**ISLE OF PALMS PHASE 3
INTERNAL DRAINAGE IMPROVEMENTS**

**T&H PROJECT NO.
J-27670.0003**

ADDENDUM NO. 1

October 23, 2020

U1.3

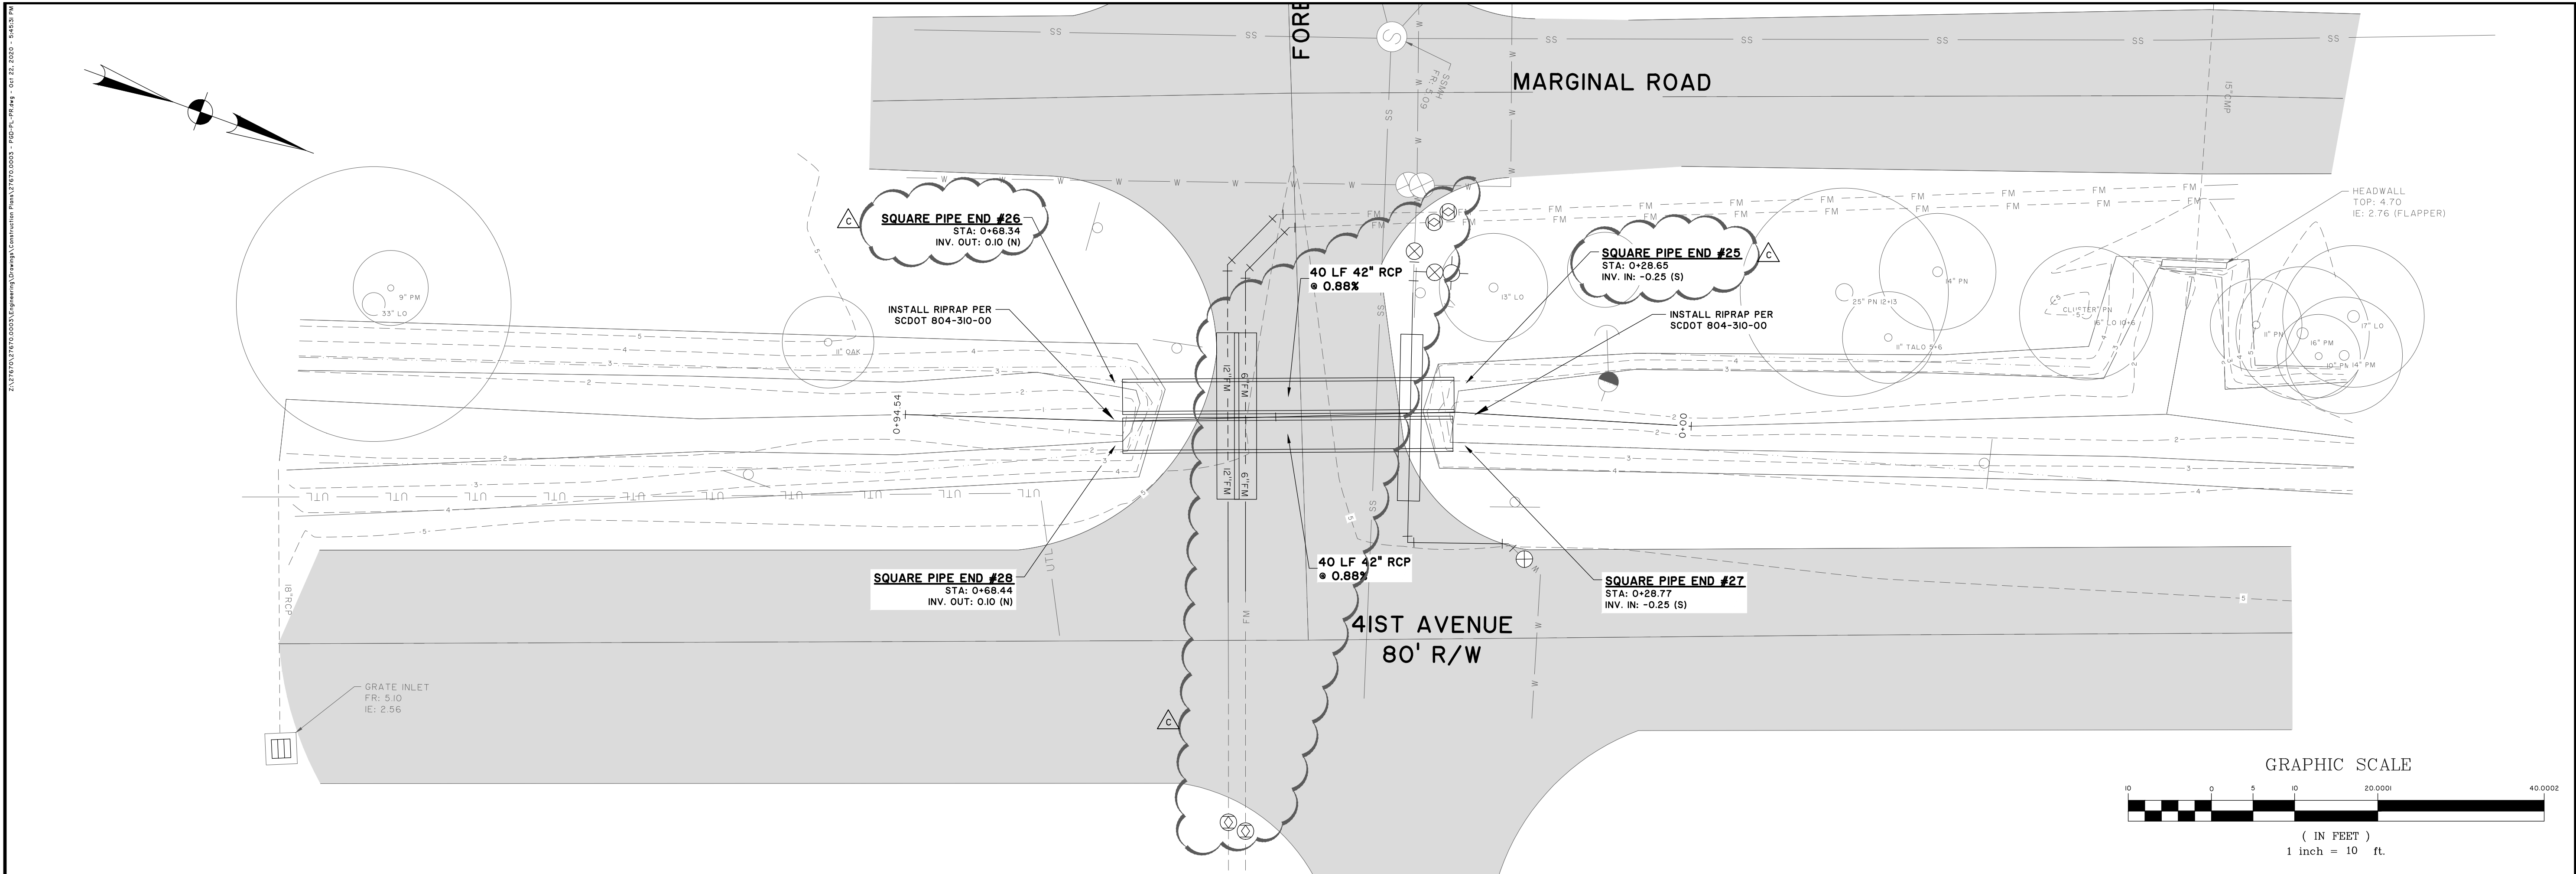
1. Note **12** on Sheet **U1.3** has been revised as follows:

Contractor shall install line stops in each the 6-inch forcemain and the 12-inch forcemain (2 per forcemain, either side of proposed offset).

2. The following has been added as Note **13** to the plan sheet **U1.3**:

Contractor shall provide a minimum of 14 calendar days notice to IOPWSC and shall coordinate with IOPWSC for the cleaning of the 12-inch and 6-inch forcemains. After the installation of the line stops and the removal of the existing forcemains, the contractor shall allow IOPWSC access to the work site (while the trench is open) to clean the forcemains. An appropriate amount of time (minimum of 3 days) shall be allotted to IOPWSC for the cleaning. IOPWSC shall be responsible for all work associated with cleaning the lines – including collecting and disposal of fluids and maintenance of trench during cleaning activities.

3. The following has been added as Note **14** to the plan sheet **U1.3**:

It is believed that flowable fill was installed as backfill (around and above) the existing 6" and 12" force mains noted on this page where the utilities are located under existing pavement. Contractor shall remove all flowable fill around and above the sections of the force mains noted to be relocated under the proposed drainage culverts. Contractor shall provide suitable backfill material and shall place and compact the material to conform to the requirements noted in Section 02731.

The cost for removal and offsite disposal of the existing flowable fill, along with the supply, placement, and compaction of suitable backfill material shall be considered inclusive of the "Utility Work Within Project Area" line item.

4. The locations of the line stops and the relocation of the force mains have been revised on plan sheets **U1.3** and **C1.6**.

- CONTRACTOR SHALL INSTALL LINE STOPS IN EACH THE 6-INCH FORCEMAIN AND THE 12-INCH FORCEMAIN (2 PER FORCEMAIN, EITHER SIDE OF PROPOSED OFFSET).
- CONTRACTOR SHALL PROVIDE A MINIMUM OF 14 CALENDAR DAYS NOTICE TO IOPWSC AND SHALL COORDINATE WITH IOPWSC FOR THE CLEANING OF THE 12-INCH AND 6-INCH FORCEMANS. AFTER THE INSTALLATION OF THE LINE STOPS AND THE REMOVAL OF THE EXISTING FORCEMANS, THE CONTRACTOR SHALL ALLOW IOPWSC ACCESS TO THE WORK SITE (WHILE THE TRENCH IS OPEN) TO CLEAN THE FORCEMANS. AN APPROPRIATE AMOUNT OF TIME (MINIMUM OF 3 DAYS) SHALL BE ALLOTTED TO IOPWSC FOR THE CLEANING. IOPWSC SHALL BE RESPONSIBLE FOR ALL WORK ASSOCIATED WITH CLEANING THE LINES - INCLUDING COLLECTING AND DISPOSAL OF FLUIDS AND MAINTENANCE OF TRENCH DURING CLEANING ACTIVITIES.

- IT IS BELIEVED THAT FLOWABLE FILL WAS INSTALLED AS BACKFILL (AROUND AND ABOVE) THE EXISTING 6" AND 12" FORCE MAINS NOTED ON THIS PAGE WHERE THE UTILITIES ARE LOCATED UNDER EXISTING PAVEMENT. CONTRACTOR SHALL REMOVE ALL FLOWABLE FILL AROUND AND ABOVE THE SECTIONS OF THE FORCE MAINS NOTED TO BE RELOCATED UNDER THE PROPOSED DRAINAGE CULVERTS. CONTRACTOR SHALL PROVIDE SUITABLE BACKFILL MATERIAL AND SHALL PLACE AND COMPACT THE MATERIAL TO CONFORM TO THE REQUIREMENTS NOTED IN SECTION 02731.

- THE COST FOR REMOVAL AND OFFSITE DISPOSAL OF THE EXISTING FLOWABLE FILL, ALONG WITH THE SUPPLY, PLACEMENT, AND COMPACTION OF SUITABLE BACKFILL MATERIAL SHALL BE CONSIDERED INCLUSIVE OF THE "UTILITY WORK WITHIN PROJECT AREA" LINE ITEM.
